August 31, 2009
NND-09-0259

Subject: Virgil C. Summer Nuclear Station (VCSNS) Units 2 and 3 Combined License Application (COLA) - Docket Numbers 52-027 and 52-028 Response to NRC Request for Additional Information (RAI) Letter No. 060

SRP Section: 02.05.02 – Vibratory Ground Motion

Figure RAI 02.05.02-21-1
Contributions to the total mean hazard (10 Hz) from each of the EPRI-SOG ESTs as well as from the updated Charleston and New Madrid seismic sources

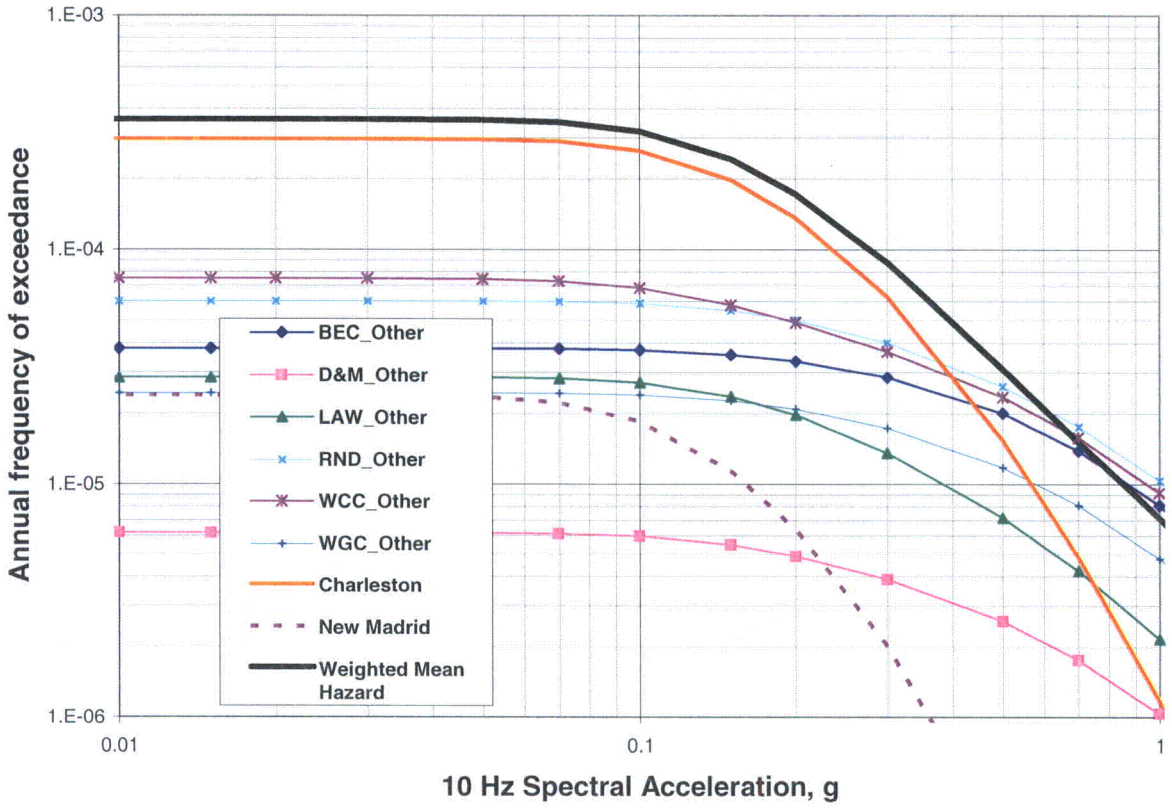
Please address the above discrepancy between the response to RAI 2.5.2-3 and the FSAR text. Specifically, please explain why the original EPRI-SOG EST Charleston seismic sources were not removed from the hazard model and instead replaced by the UCSS model in the sensitivity study results presented in response to RAI 2.5.2-3. Please re-evaluate the response to RAI 2.5.2-3 without using the EPRI-SOG Charleston seismic source models. In addition, please provide an electronic data file containing the contribution to the total mean hazard (1 and 10 Hz) from each of the EPRI-SOG ESTs as well as updated Charleston and New Madrid seismic sources, separately. Please also verify that the final hazard results (and resulting GMRS) reflect the inclusion of the UCSS rather than the original EPRI-SOG Charleston seismic source models.

The Table RAI 02.05.02-21-1 and Figures RAI 02.05.02-21-1 and RAI 02.05.02-21-2 below show the contribution to the weighted mean hazard (1 and 10 Hz) separated into contributions from the UCSS, New Madrid, and conditional (unweighted) mean hazards from the remaining sources for each of the EPRI-SOG ESTs
